**Final Phase of Cleanup Activities
at
S&W Atlas Iron and Metal Company, Inc.
10019 South Alameda Street
Los Angeles, California.**

The attached work plan has been approved by DTSC, subject to completion of an anticipated settlement in *People of the State of California, et al. v. S & W Atlas Iron and Metal Co., et al.*, Los Angeles Superior Court Case No. BC 316733, and with the following corrections:

**REMEDIAL ACTION WORK PLAN
– FINAL PHASE
FOR ATLAS IRON & METALS, INC.**

REED INTERNATIONAL, LTD.
 Figure 3
HI-20 PAD PLAN AND SECTION
 ATLAS METALS
 10019 ALAMEDA ST., LOS ANGELES, CALIFORNIA
 DATE: 2-19-07 | SCALES SHOWN | DRAWN BY: PPV
 STATE

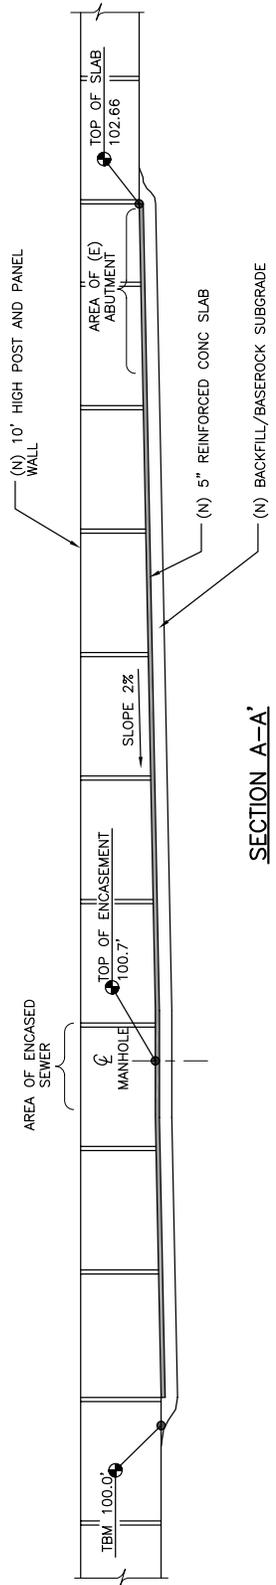
- Figure 3, Cross Section A-A, the 5" reinforced concrete slab should be changed to 6".
- The typo on Page 3.3, first paragraph, duplicate "will be" should be corrected.
- On page 1.1, in the first paragraph of the work plan, the reference to "late Summer, 2007" should be changed to "early 2008."
